BLACK RIVER

GENERAL ARRANGEMENT

BLACK RIVER BRIDGE
19.5 MILES SOUTH OF MANITOUWADGE

KING'S HIGHWAY No. 614 (SEC.) DIST. No. 18
DIST. THUNDER BAY
TWP. LOT. CON.

SITE No. 48E-27 W.P. No. 114-64
CONTRACT No. [Blank]
DRAWING No. D6089-4

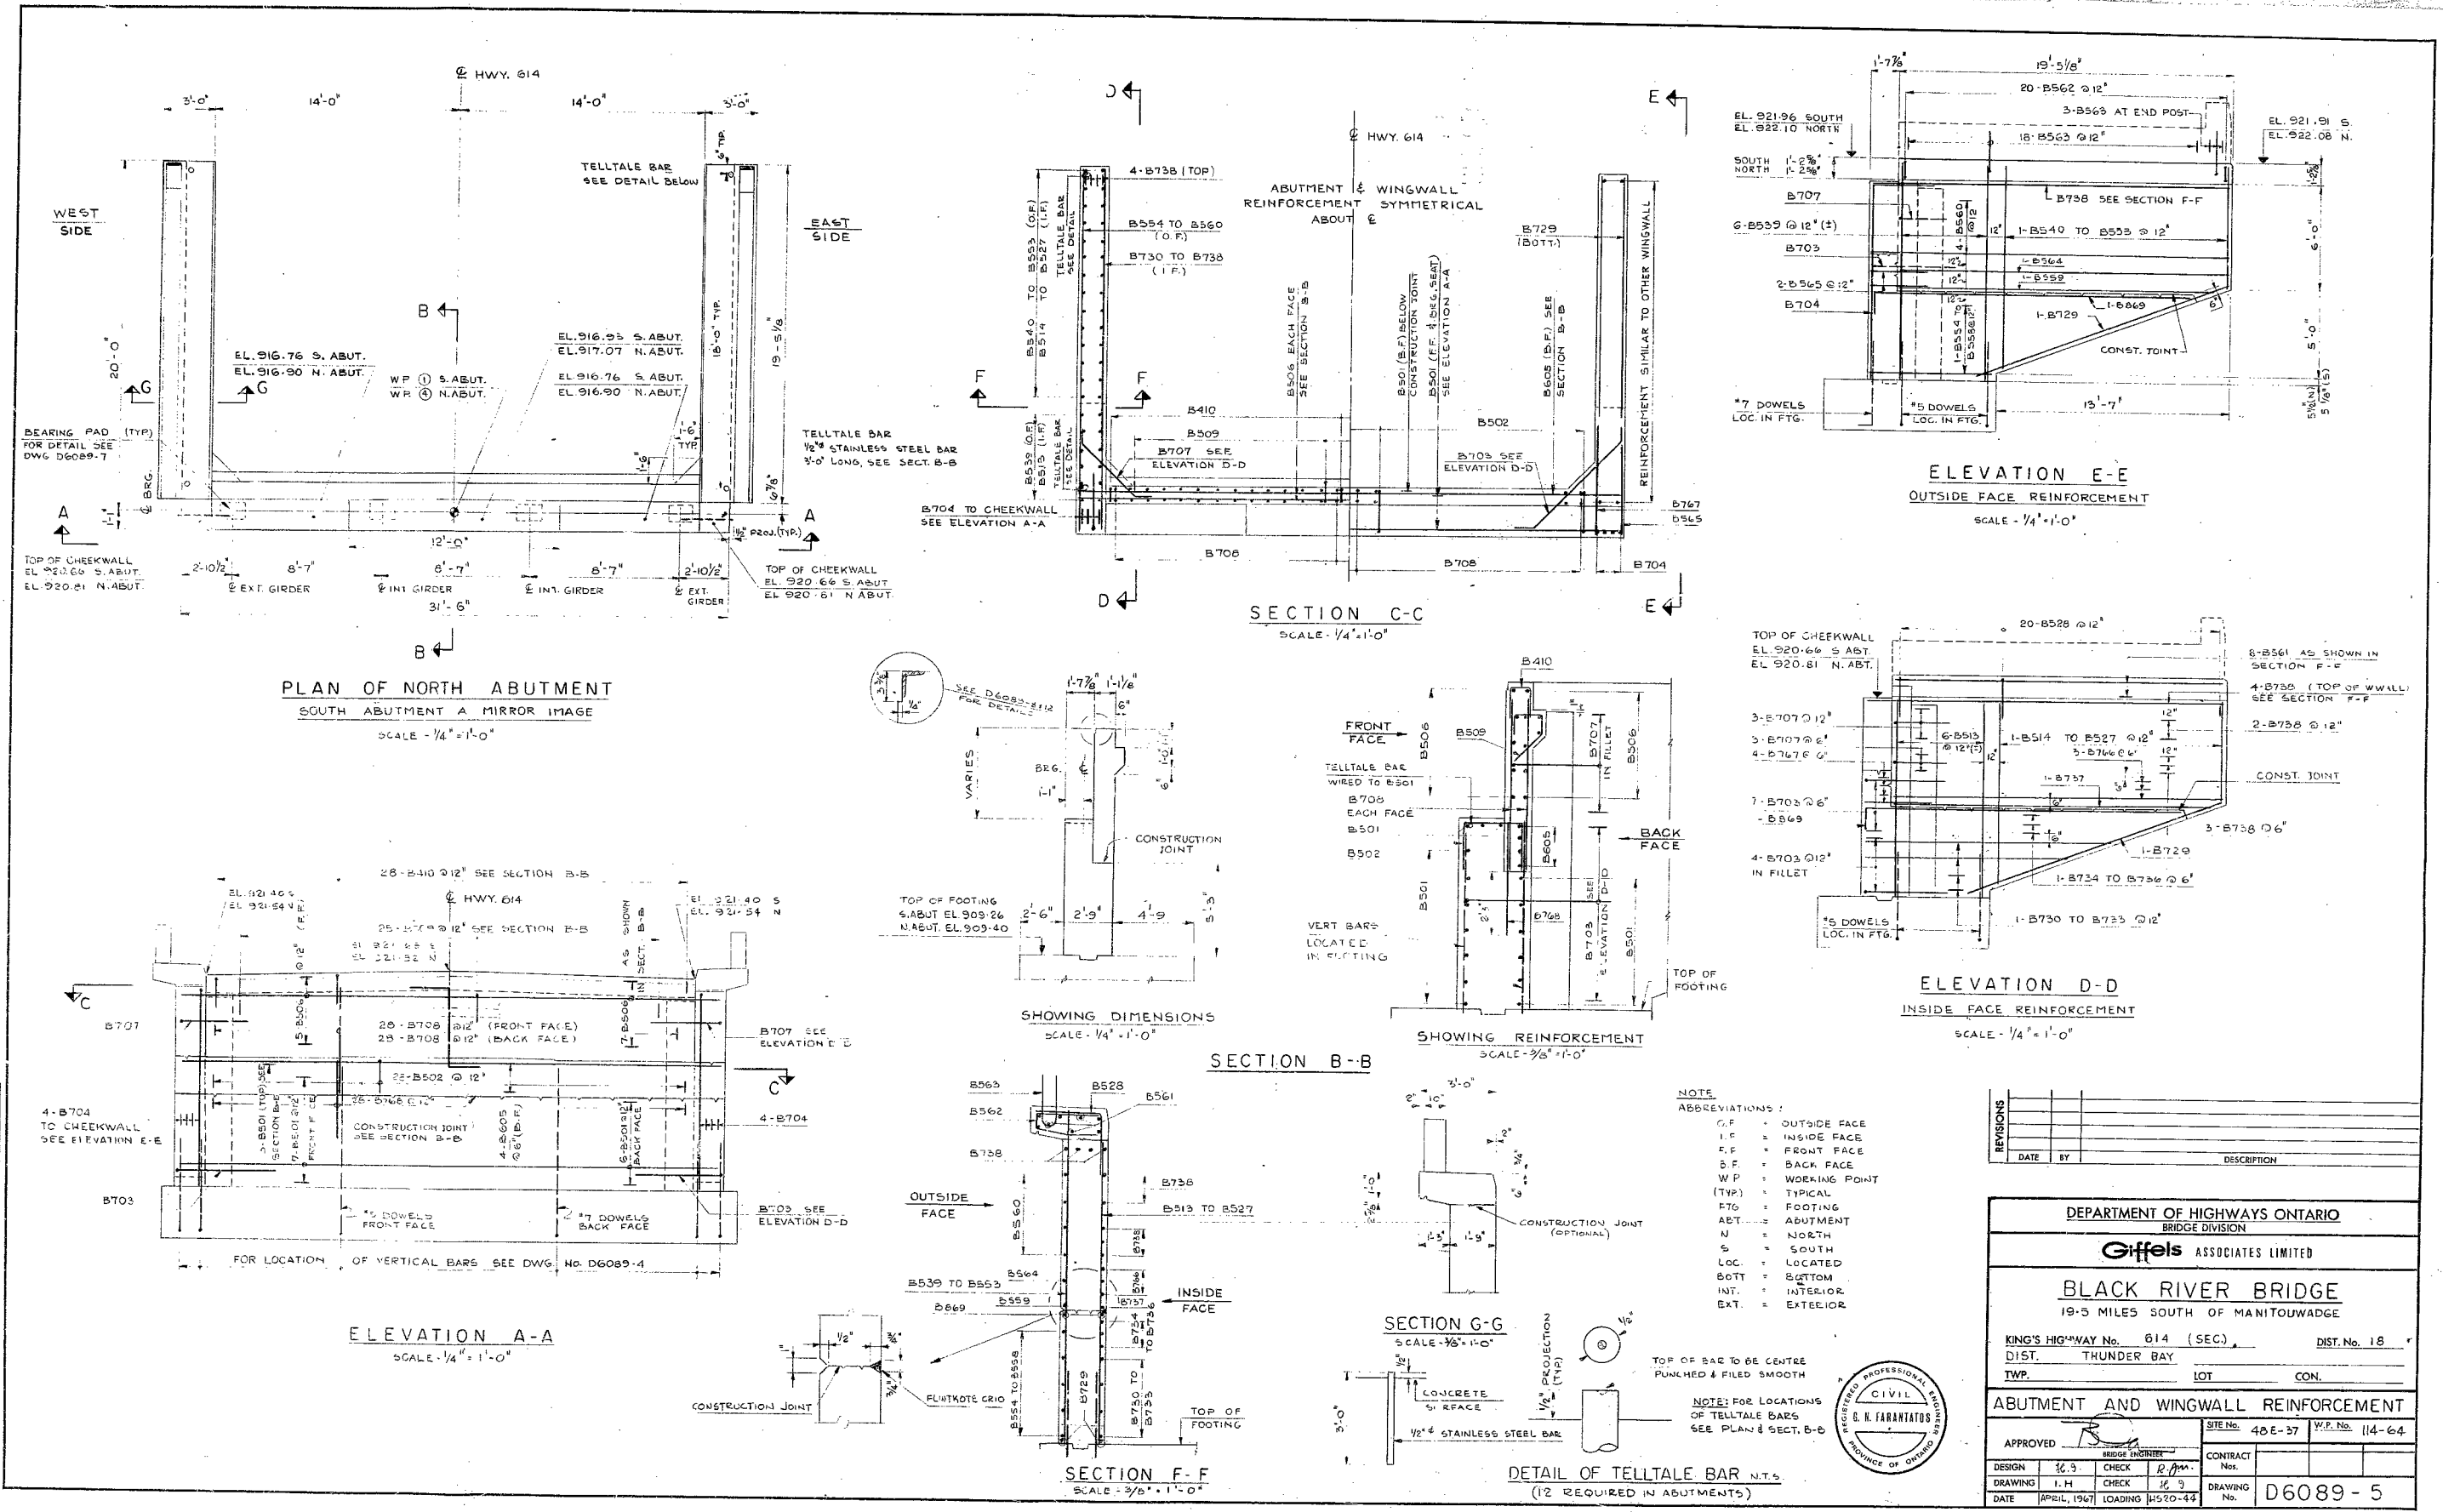
As requested during our discussion some time ago, enclosed is a final set of plans for the above structure. The limits of the First Stage of Fill have been revised as discussed, and this fill will be placed after the stream diversion has been completed and before the substructure piles are driven. A construction note calling for the excavation of pier footings to be carried out within adequately braced interlocking sheeting has also been added.

APPENDIX II
FIGURE 8
PROJECT T7923

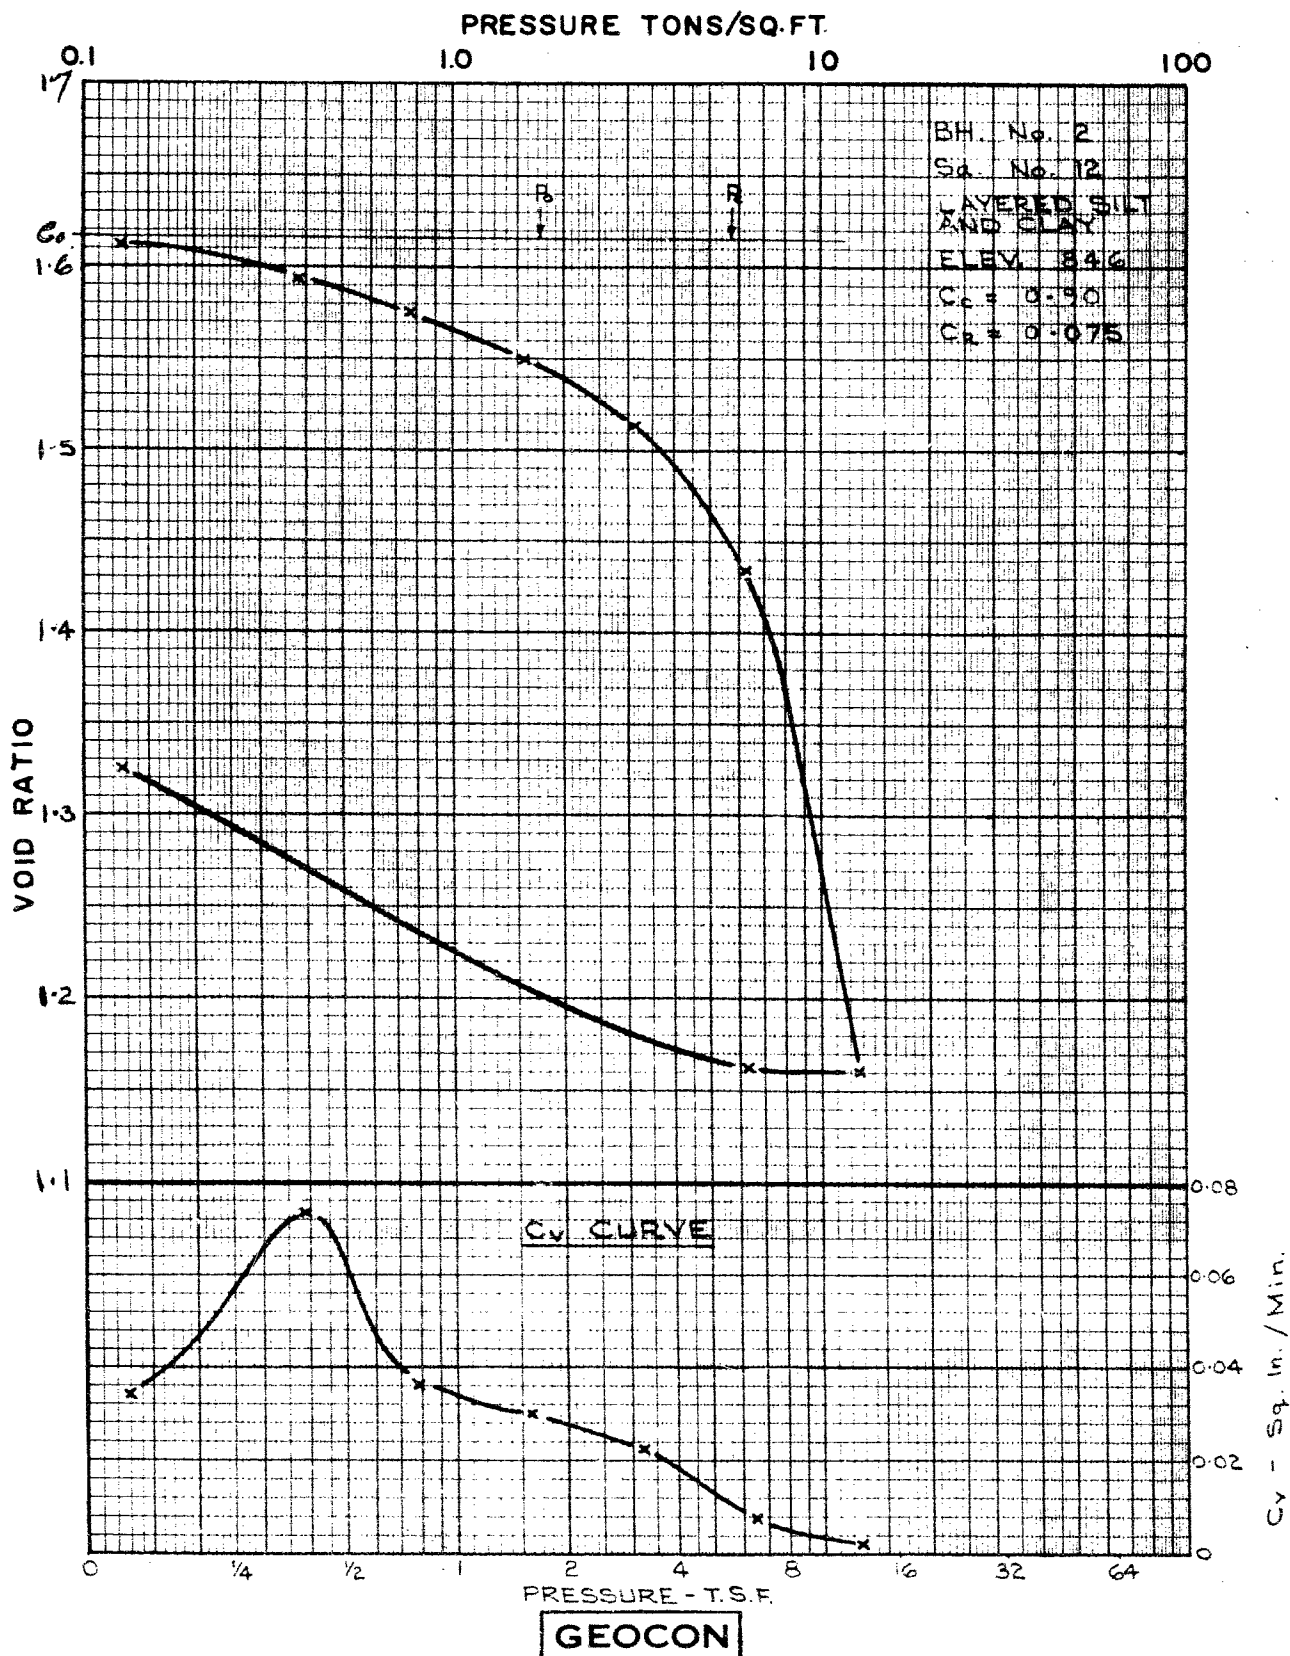
The consolidation test carried out on a representative sample of clay from the layered silt and clay stratum, and shown on Figure 8 of Appendix II, indicates that the deposit has been overconsolidated by a pressure of 4 tons per square foot in excess of existing overburden pressure. Allowing for the fact that the layered silt and clay stratum consists of approximately 60 percent thickness of silt and 40
